S4.55(2)	300.01
----------	--------

Project: 48a Queenscliff Road, Queenscliff
Client: Margaret & Stephen Stanton
Job no.: STAN01

drawing: Proposed Section A-A &
South-West Elevation
drawn by: JDP checked by: JLP

UNIT 5 PLAN

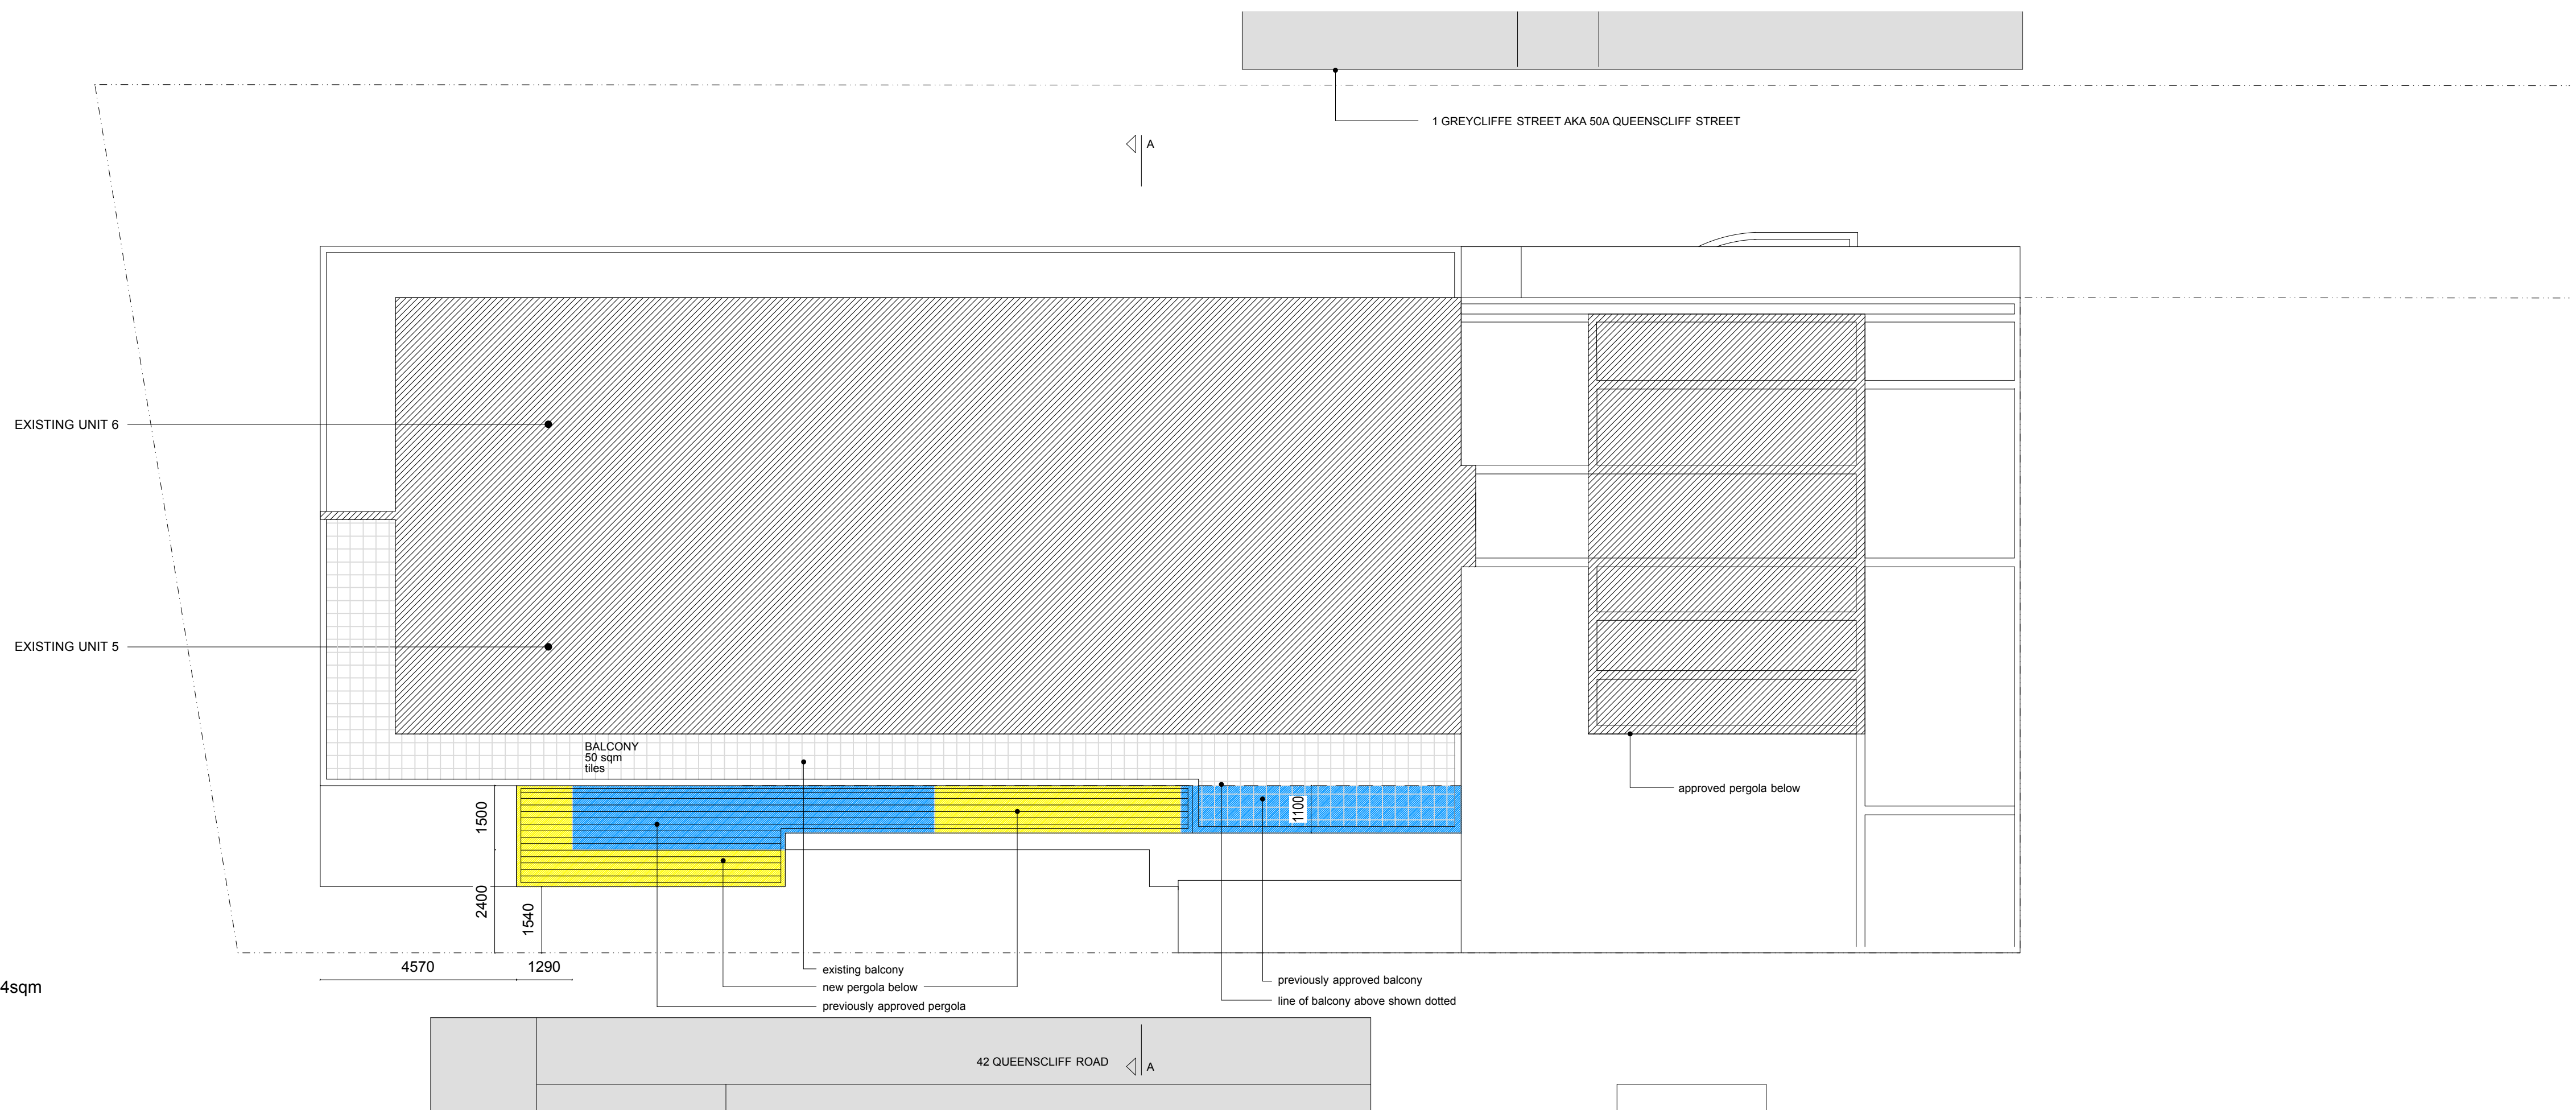
external (pergola only) = 14sqm

A: Extend pergola

UNIT 3 PLAN

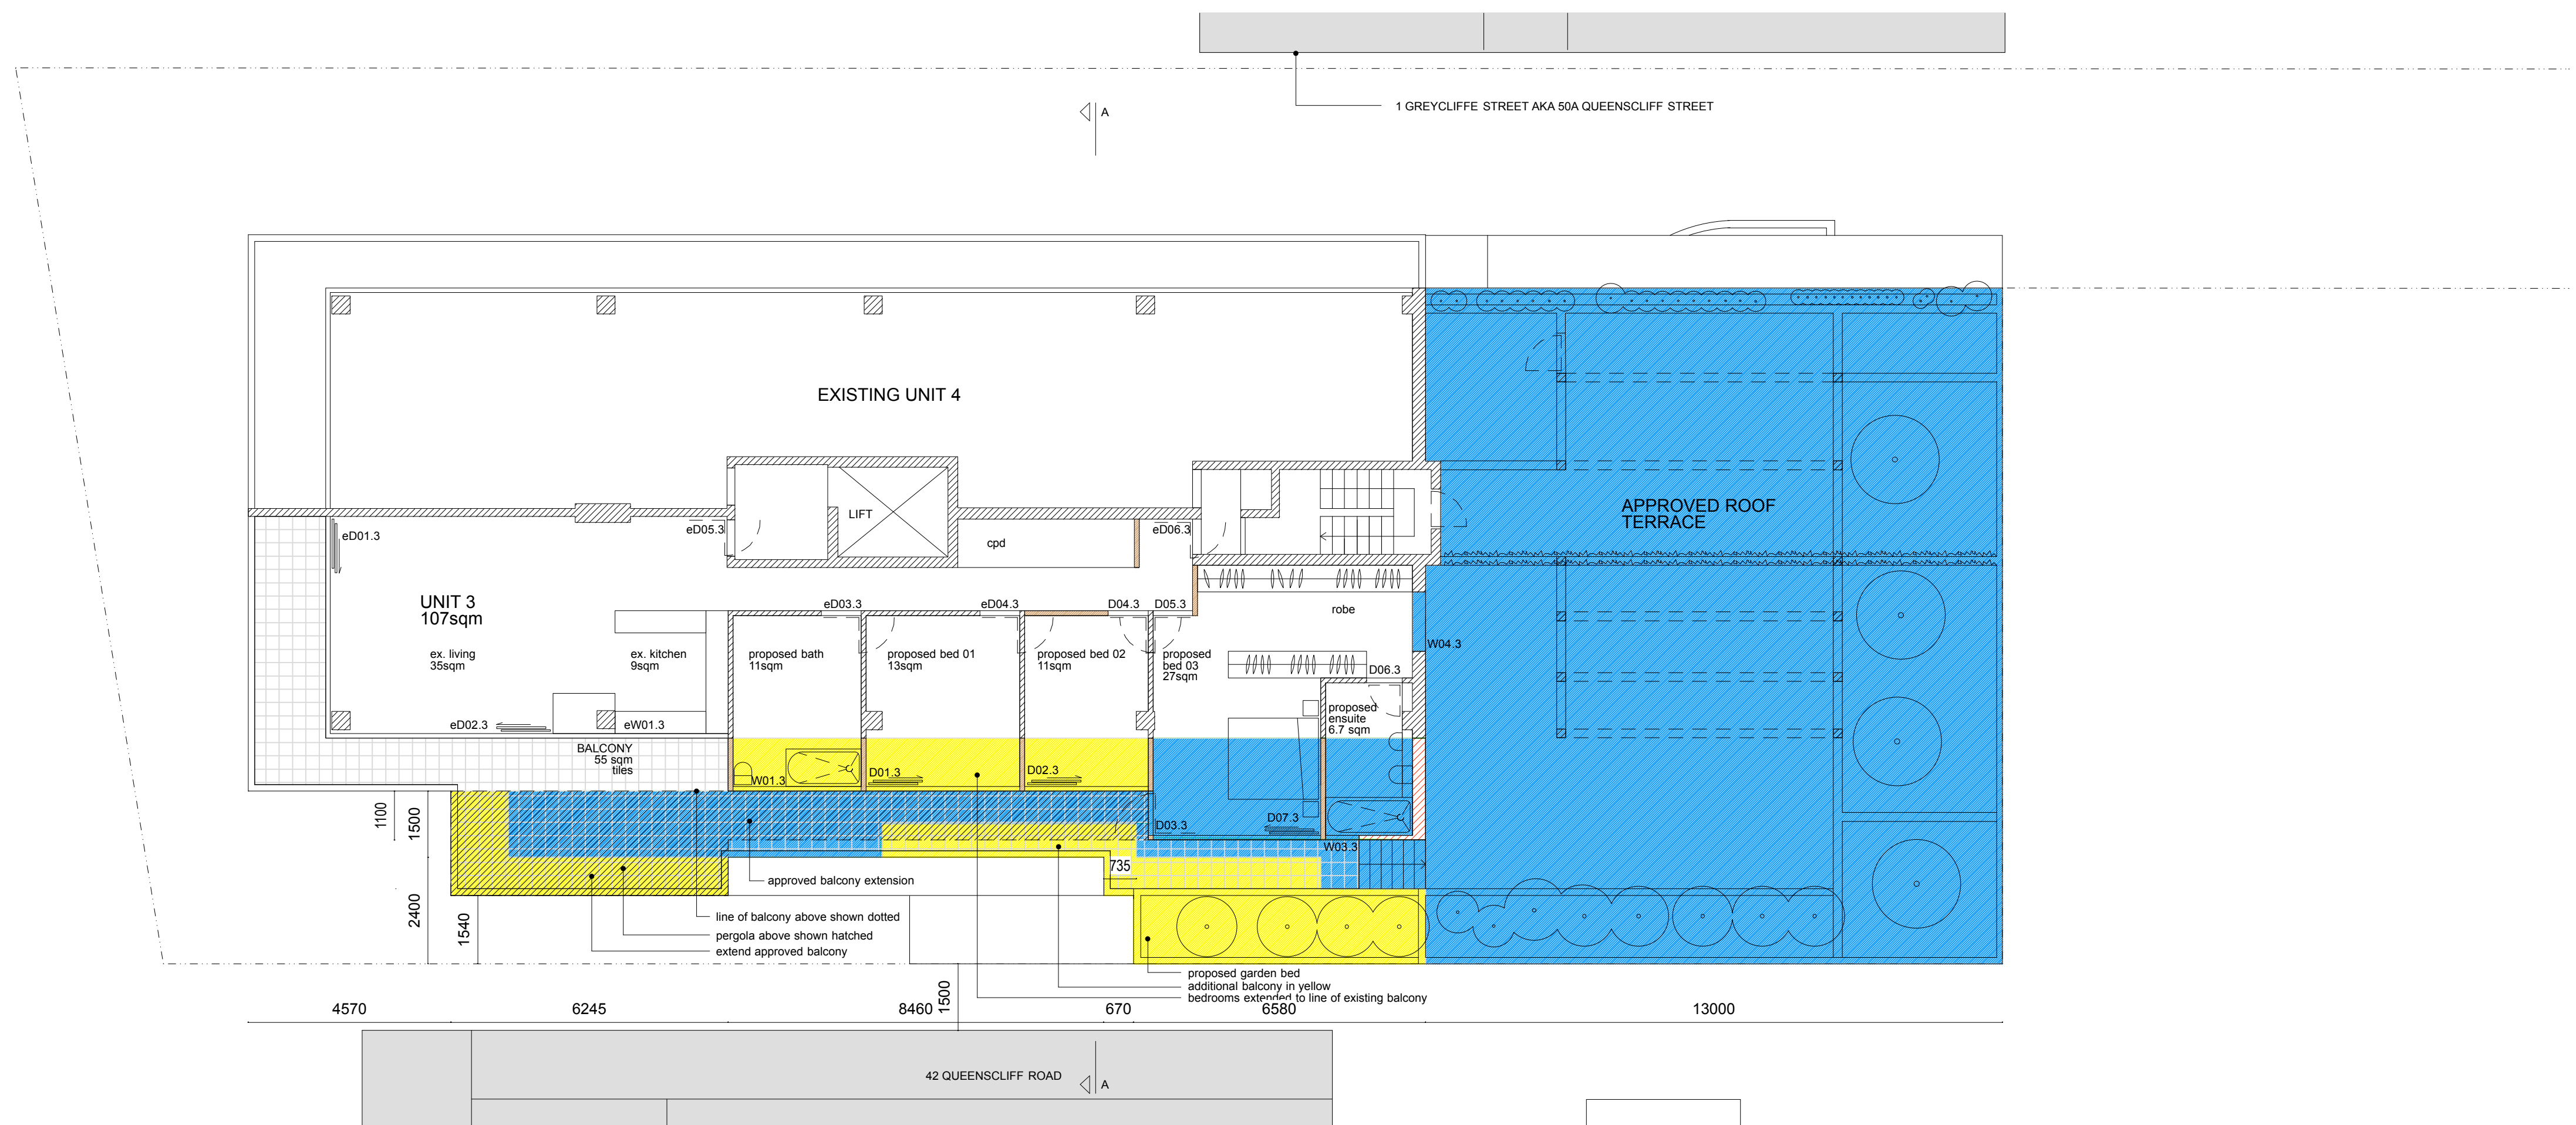
internal	= 11sqm
external	= 26sqm

A: Extend balcony to match unit 1 balcony below with cutaway to improve solar access to unit 1
B: Extend internal bath, bed 01, bed 02, 1.2m wider

PROPOSED SECTION A-A

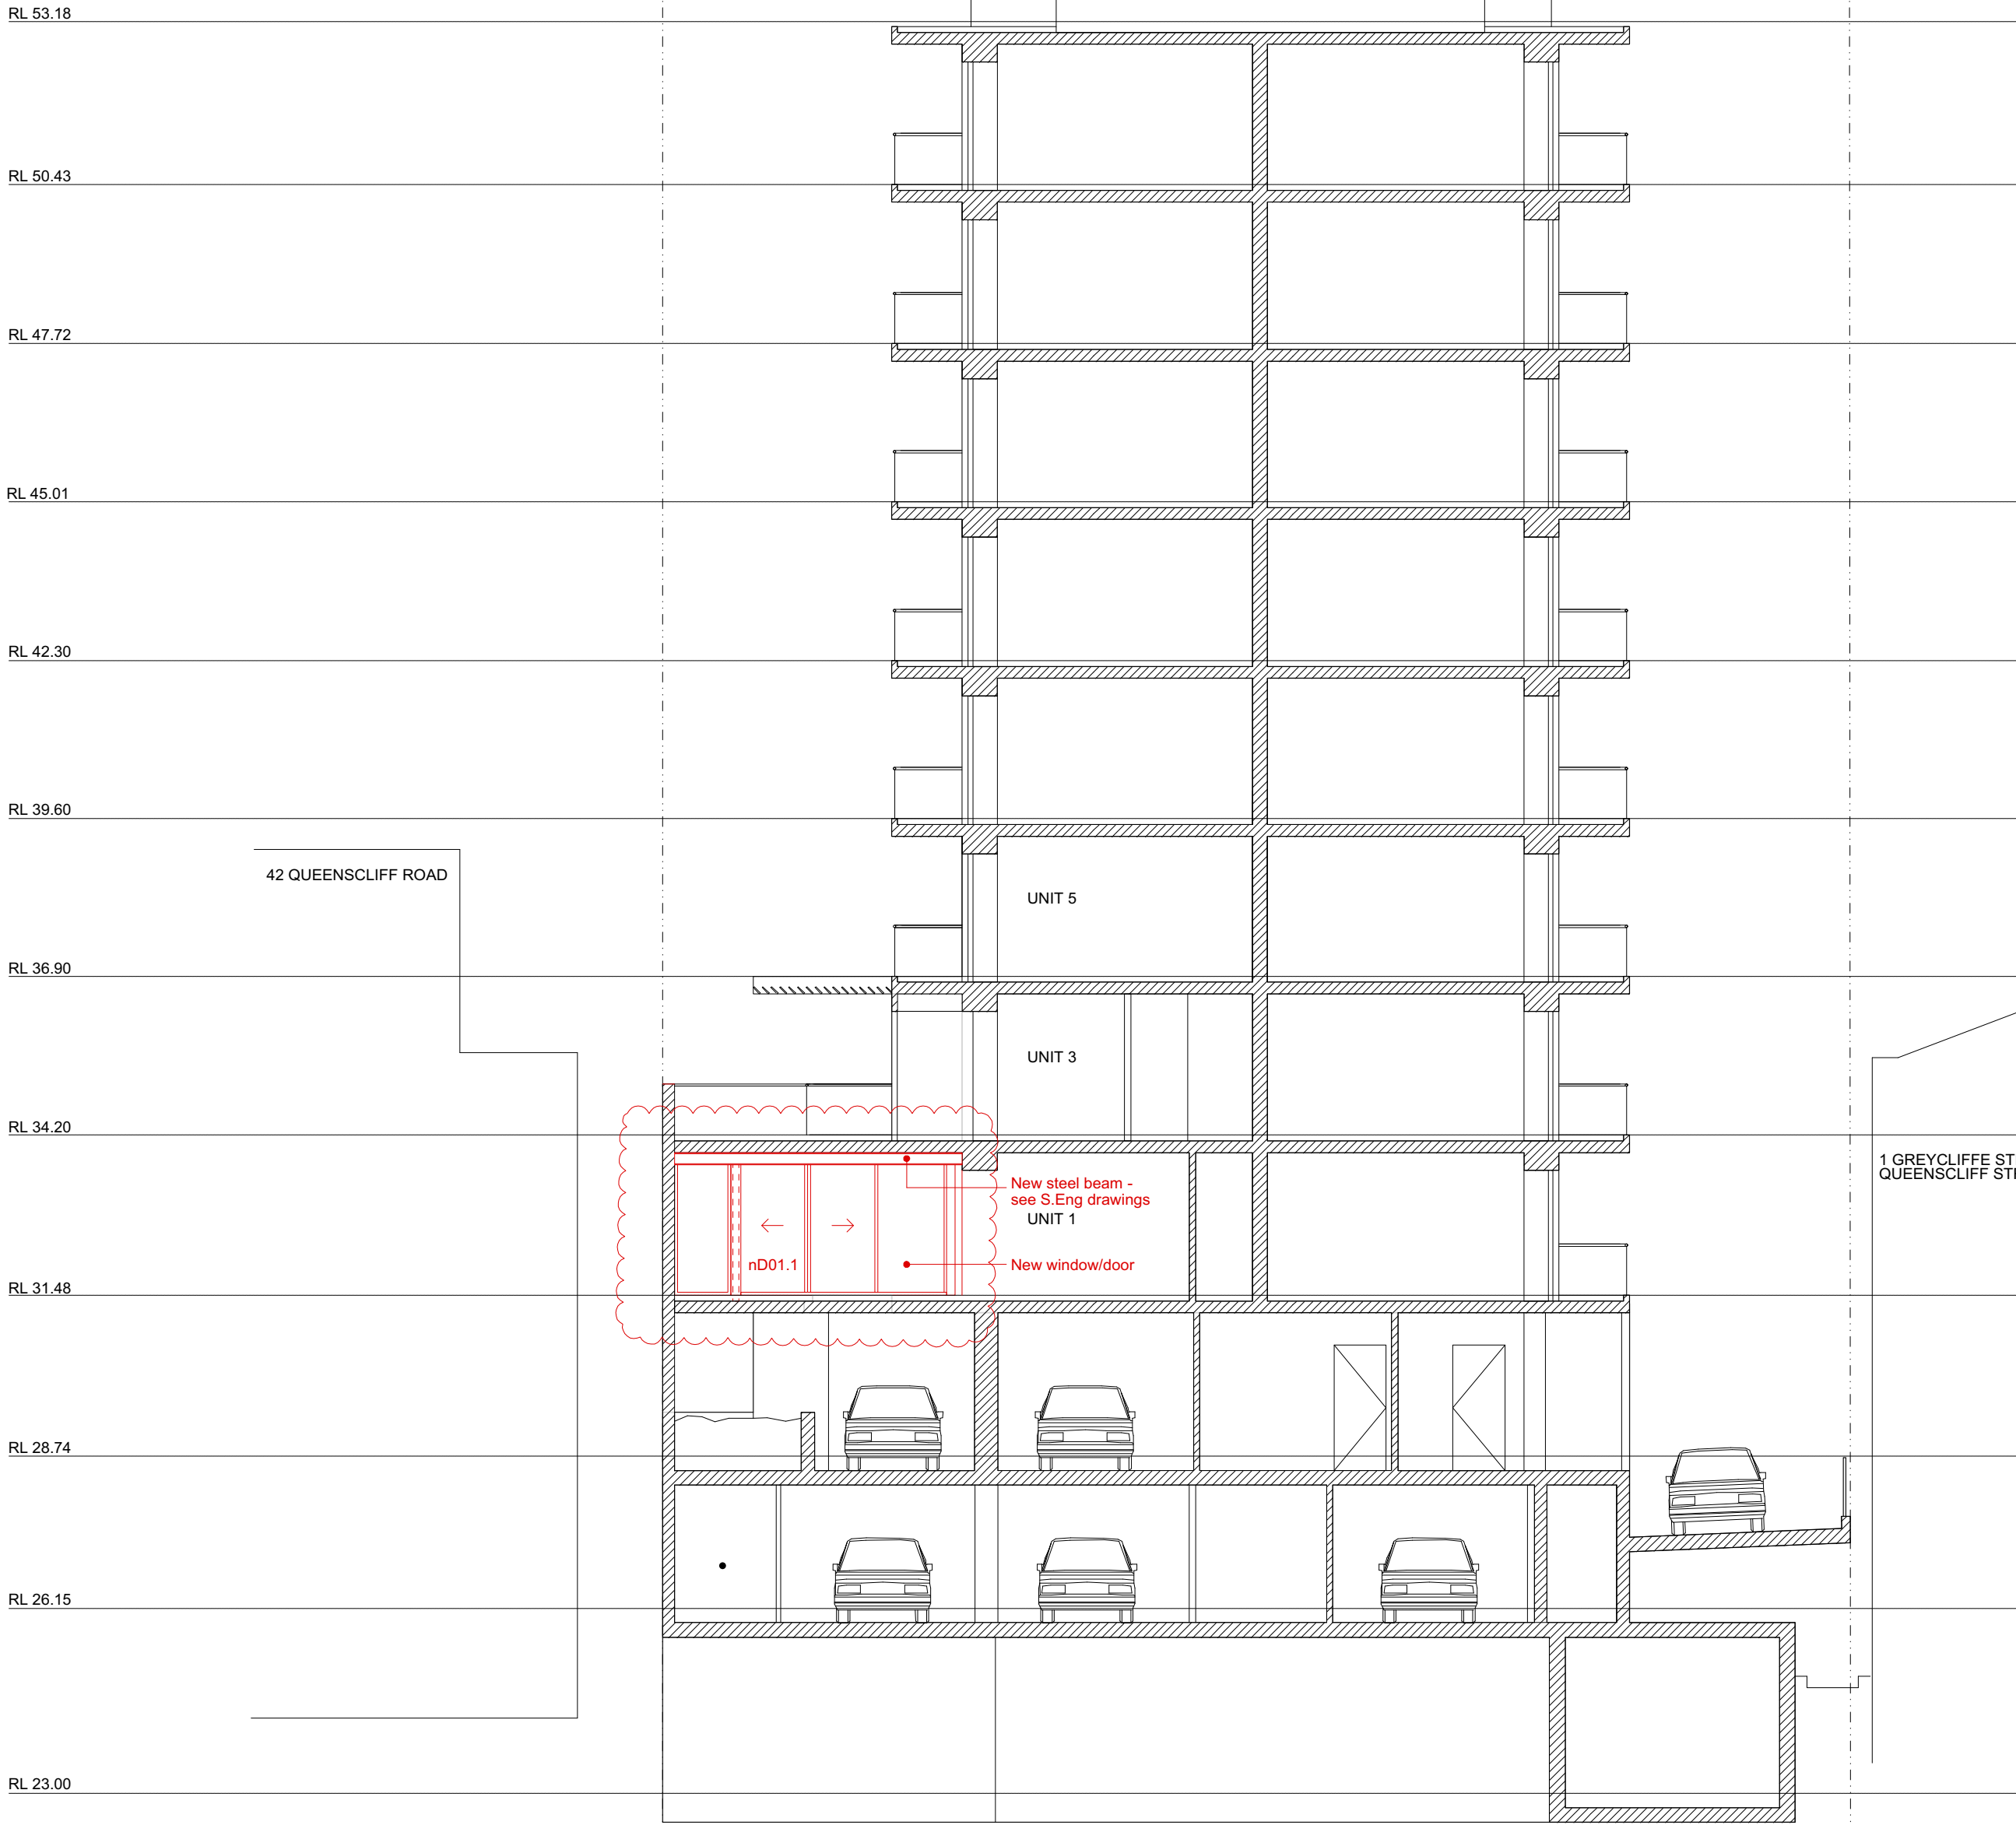
Proposed new door to Bedroom 2. Door to be approx 570mm narrower than existing. New door to generally match existing as far as practicable.
